Development Application Objection – Barina Quarry Modification

I **object to the proposed modification of the Barina Quarry** (Application No: DA1-01-2000-Mod-3, DA1-01-2000) on the following grounds:

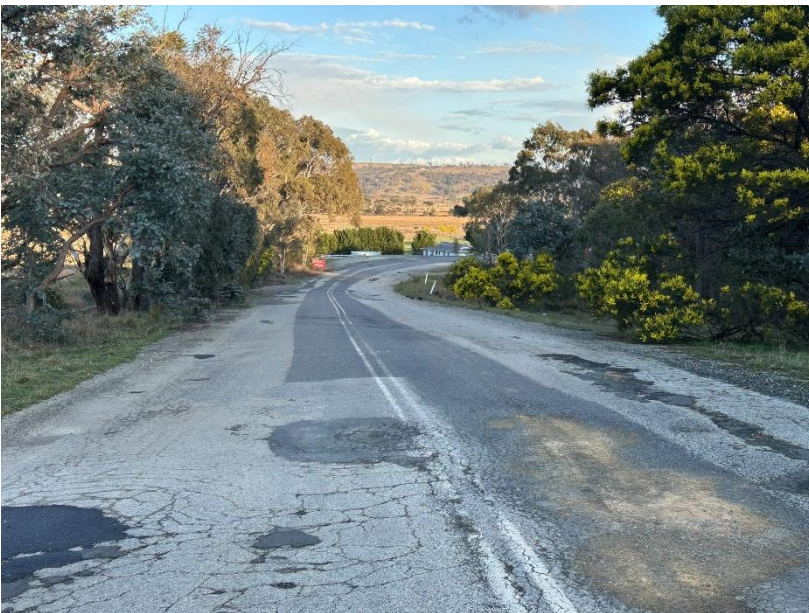
- The road is already in poor repair any truck movements prior to the road upgrade will cause additional damage to our vehicles – see images at the end of my objection.
- Any road upgraded should also ensure that mature eucalypts other trees on the road shoulder of either side of Collector Road are preserved and not damaged in any road upgrades – see images at the end of my objection.
- Despite the consultant’s conclusion that no upgrades are “required” to the intersection of Federal Highway and Collector Road, lived experience of residents indicates otherwise.

Mature eucalypts other trees on the road shoulder of either side of Collector Road are preserved and not damaged in any road upgrades.

Existing surface of Collector Road, just outside the gate of Barina Quarry – 9 September 2025 clearly show the poor condition of the road.

Existing surface of Collector Road – 9 September 2025 – road is clearly not wide enough for trucks and surface is poor.

Deceleration lanes at the intersection of Collector Road and Federal Highway

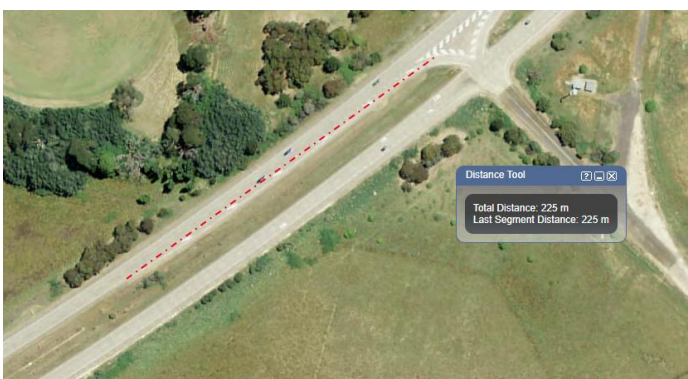
- The acceleration and deceleration lanes at this location are not long enough for fully laden trucks to get to 110 kms in the existing acceleration lane or reduce speed safely from 110 kms per hour in the deceleration lane prior to turning onto a rural road.

Turning Left from the Federal Highway to Collector Road – deceleration lane is 258 m.

Turning Right from the Federal Highway to Collector Road – deceleration lane is 225 m

Turning north from Collector Road on to the Federal Highway – acceleration lane is 313m (towards Goulburn)

Turning south from Collector Road on to the Federal Highway – acceleration lane is 105m (towards Canberra)
